# **I-81 VIADUCT PROJECT – PHASE 1, CONTRACT 2**

**PIN 3501.91, Contract D900056**

**Addendum #9**

**March 3, 2023**

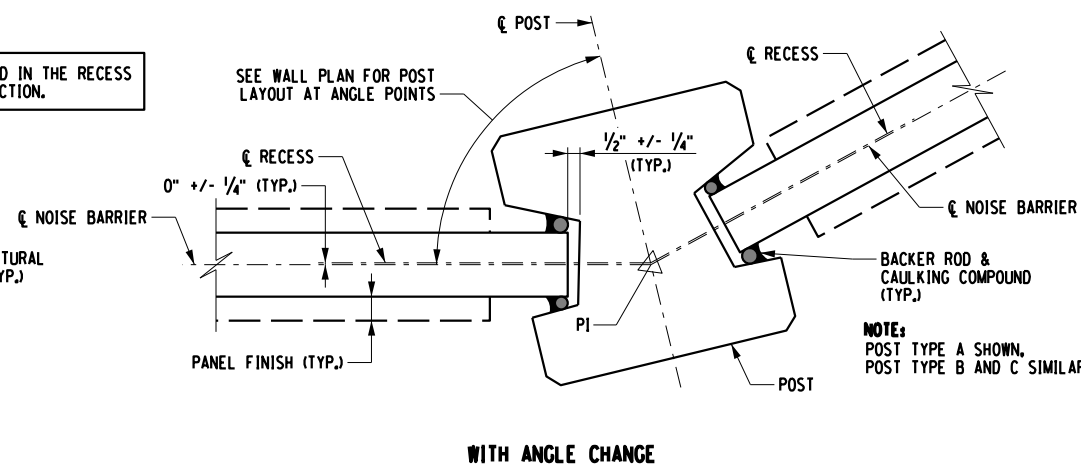
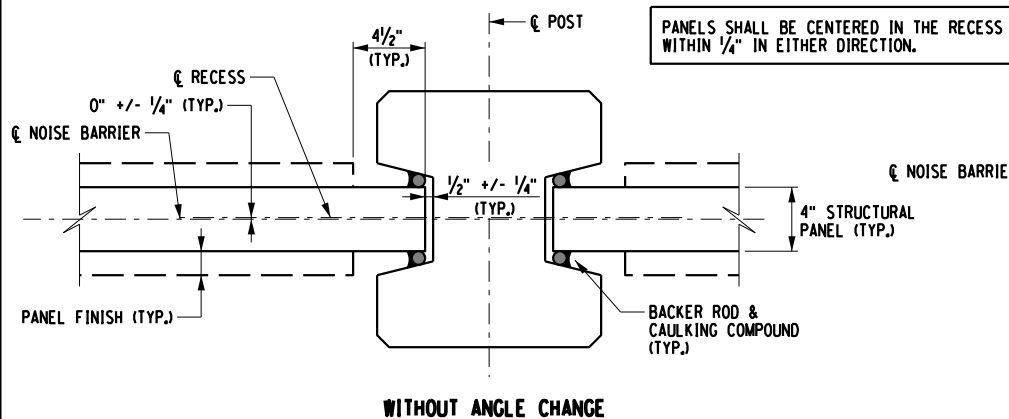
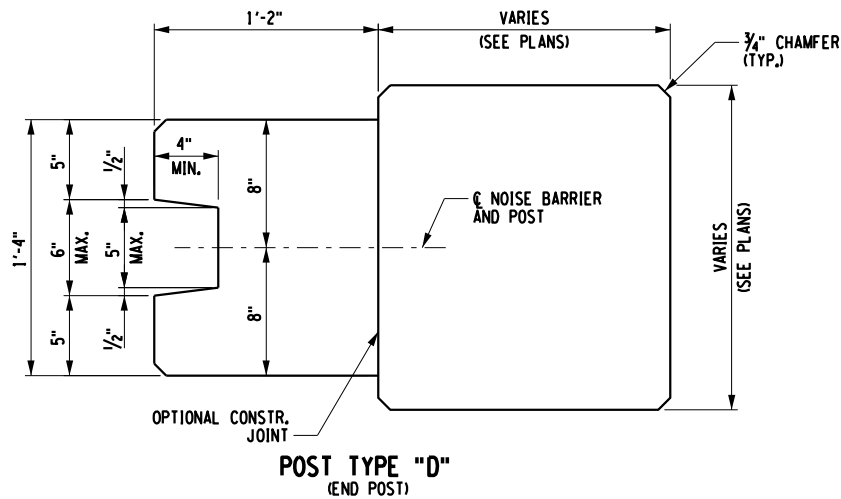
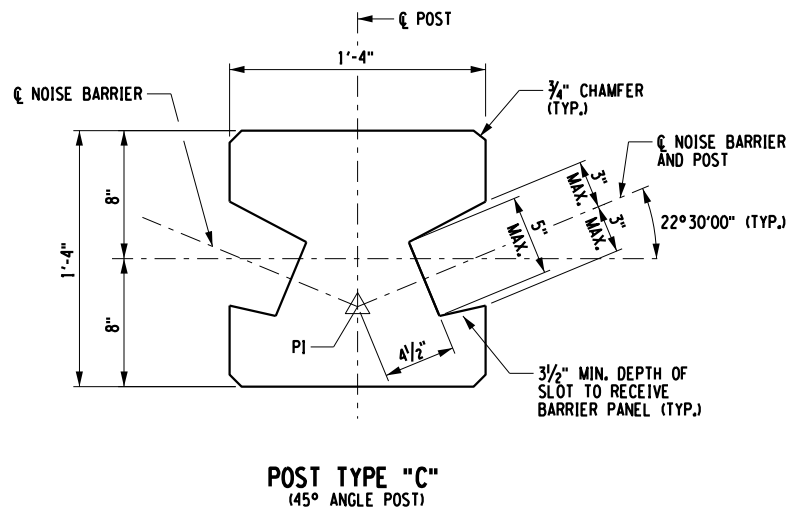
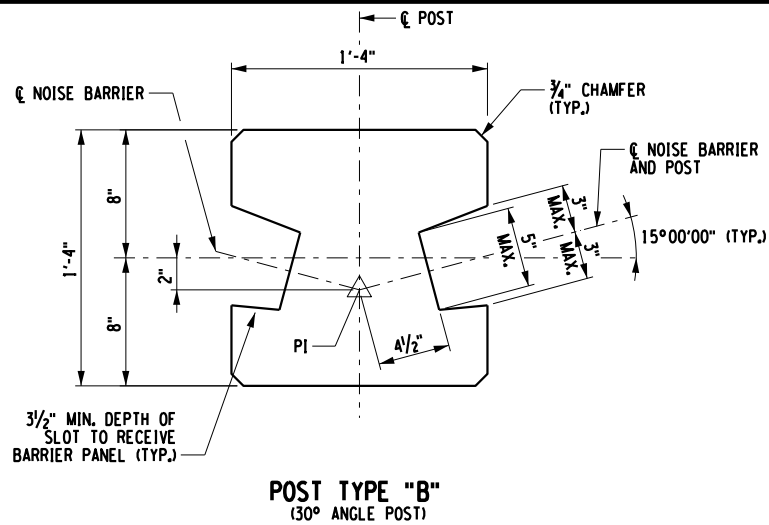
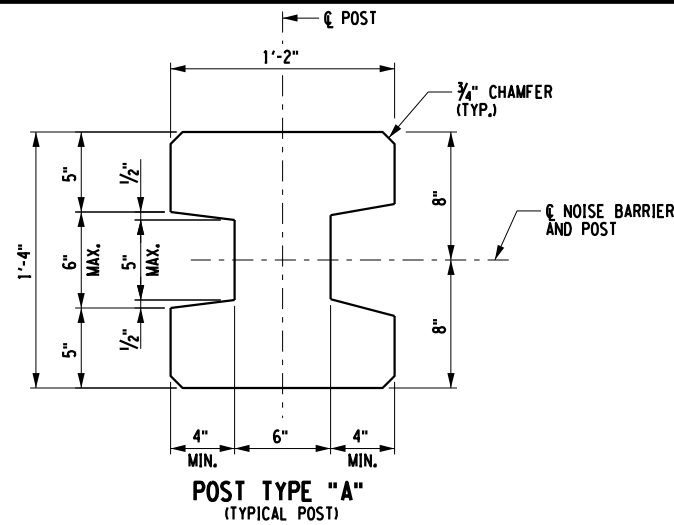
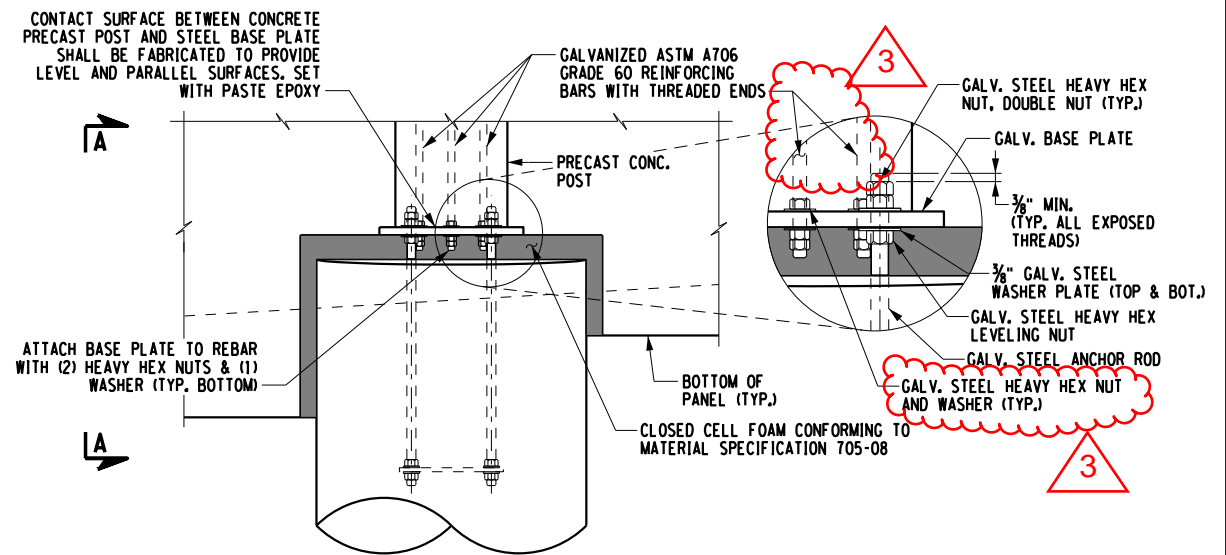
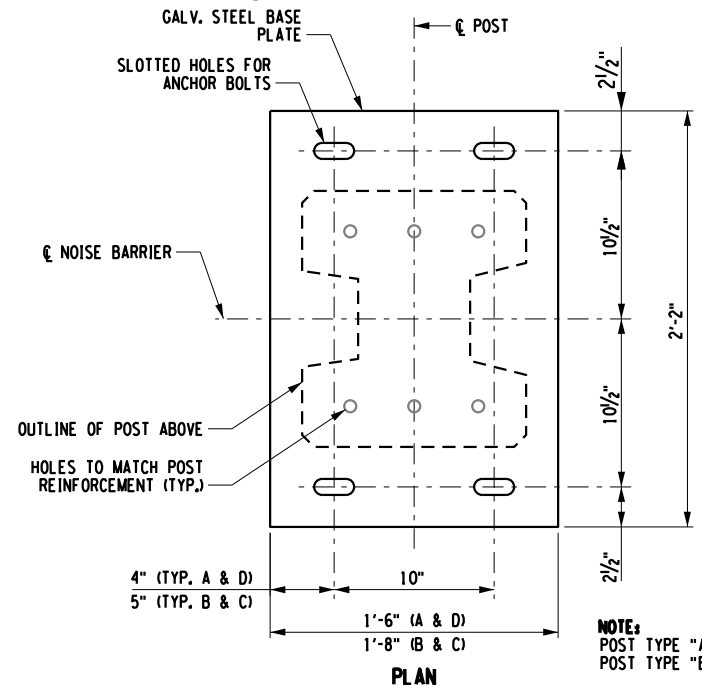
3 REVISED DIMENSIONS,  
NOTES, DETAIL, AND  
SHEET TITLE

I-191 VIADUCT PROJECT		PIN 3501.91	BRIDGES	CULVERTS	ALL DIMENSIONS IN FT UNLESS OTHERWISE NOTED	CONTRACT NUMBER
COUNTY: ONONDAGA COUNTY, NY		REGION: 3			PHASE 1, CONTRACT 2 INDICATIVE PLANS SIGNING PLAN	DRAWING NO. SG-08
						SHEET NO.

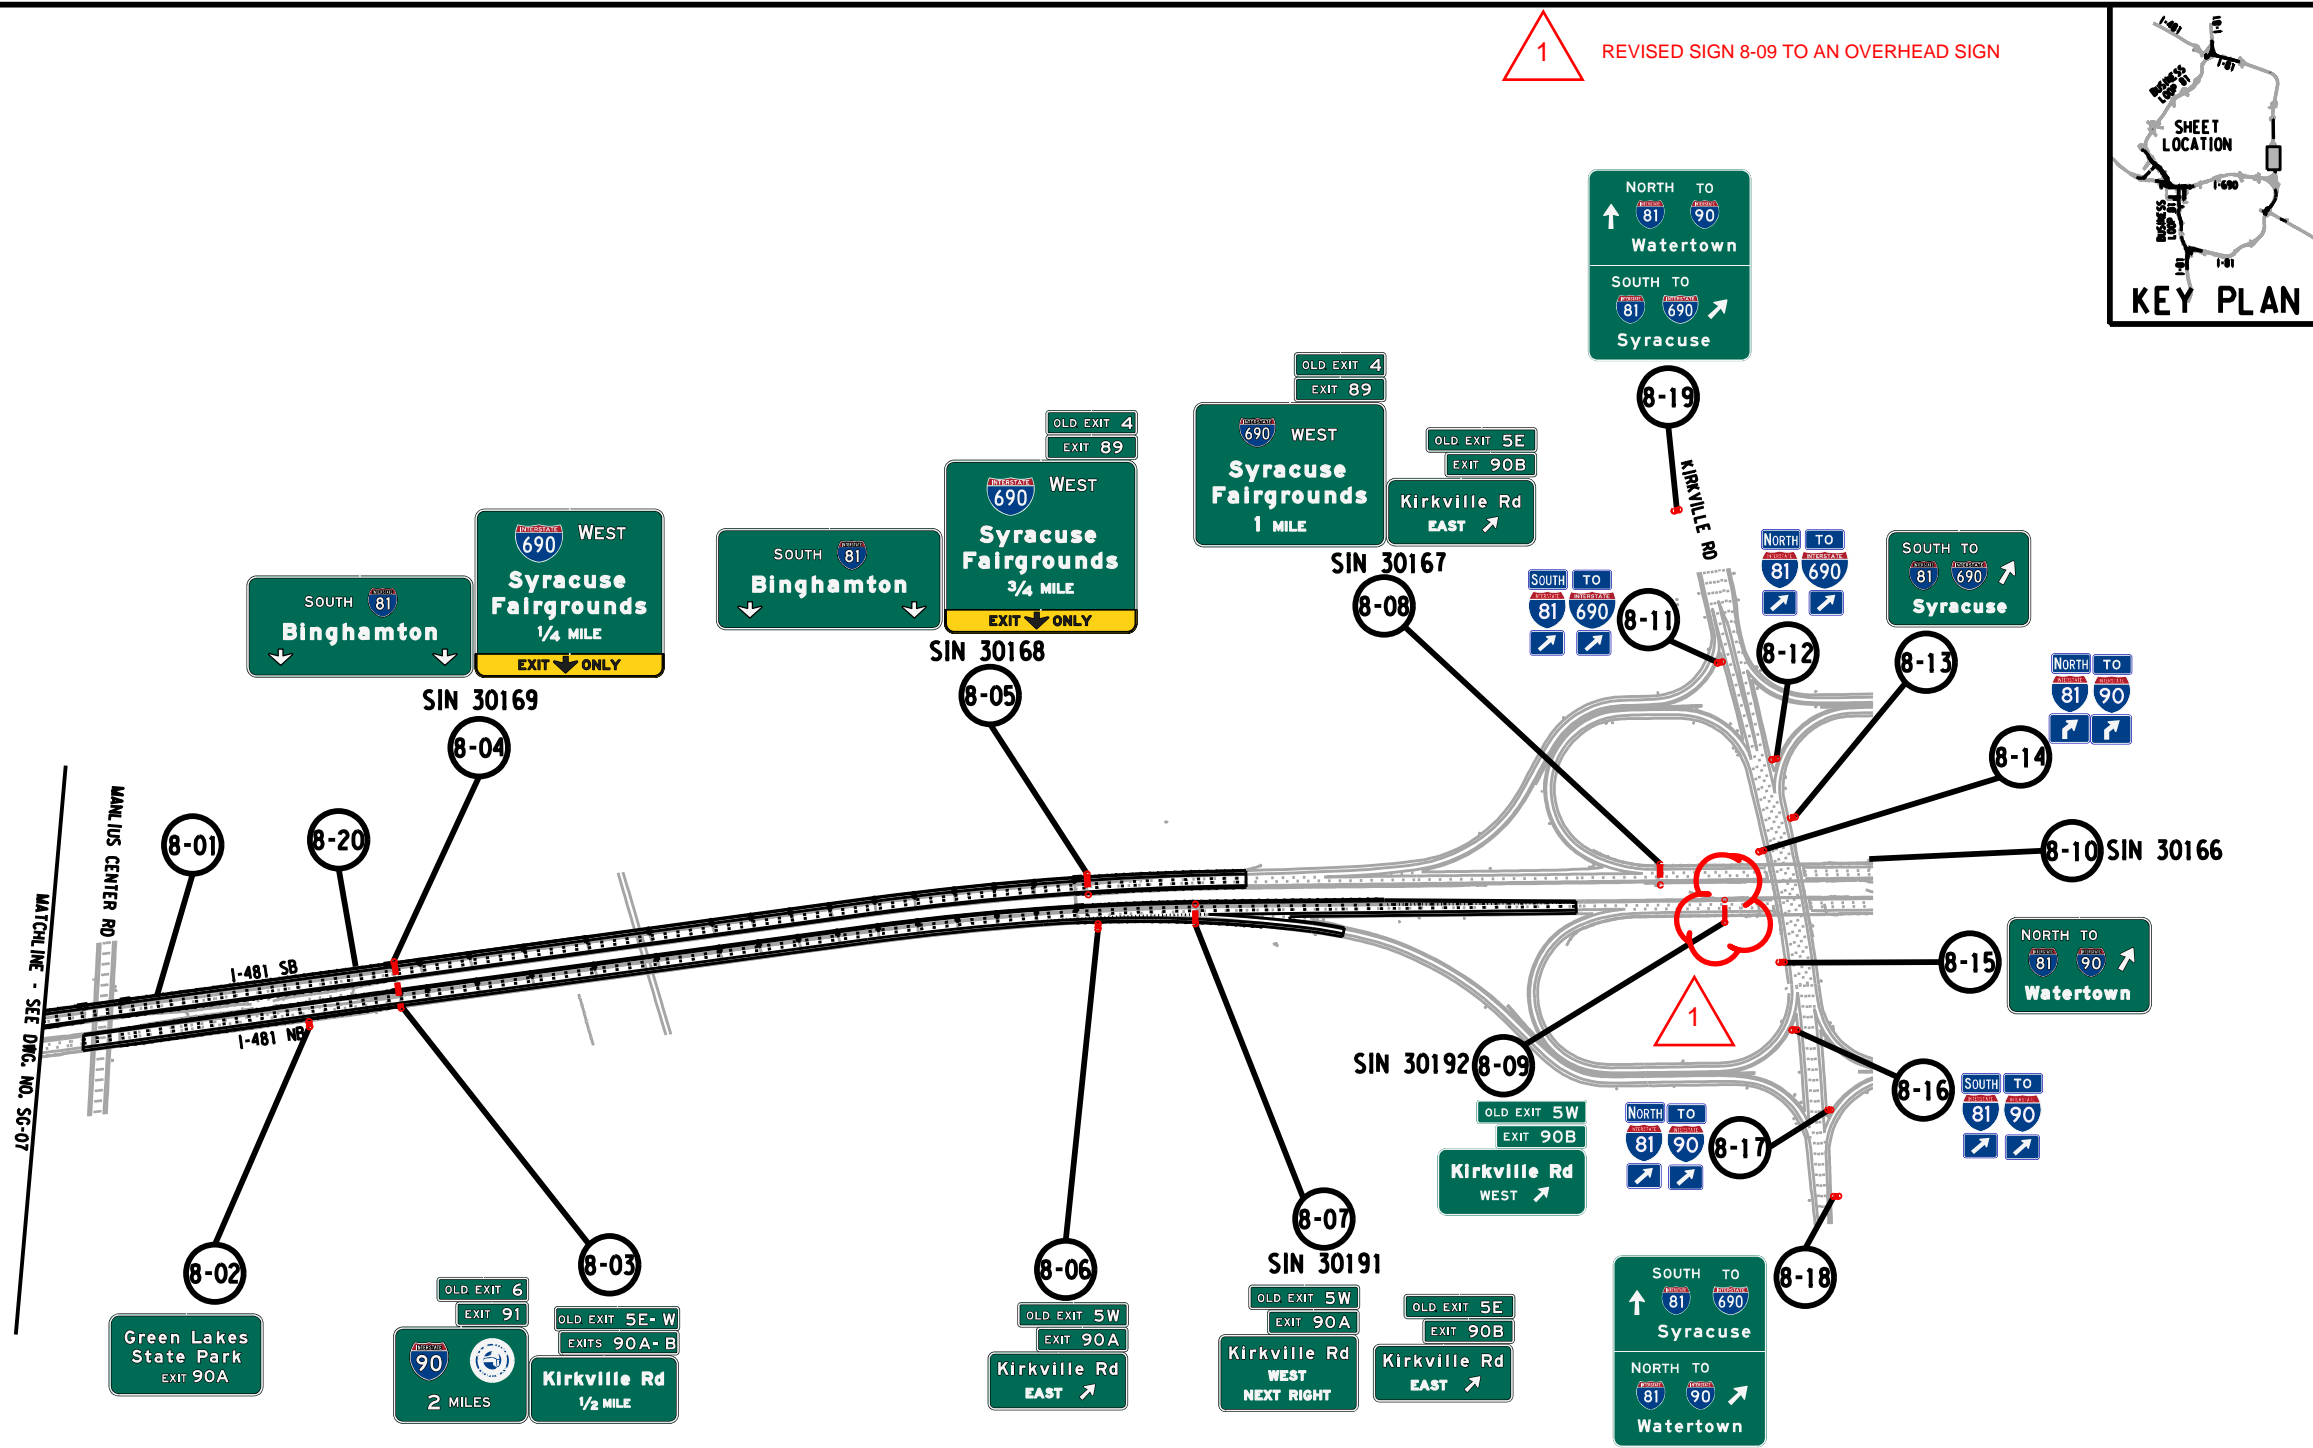
REVISED NOTE
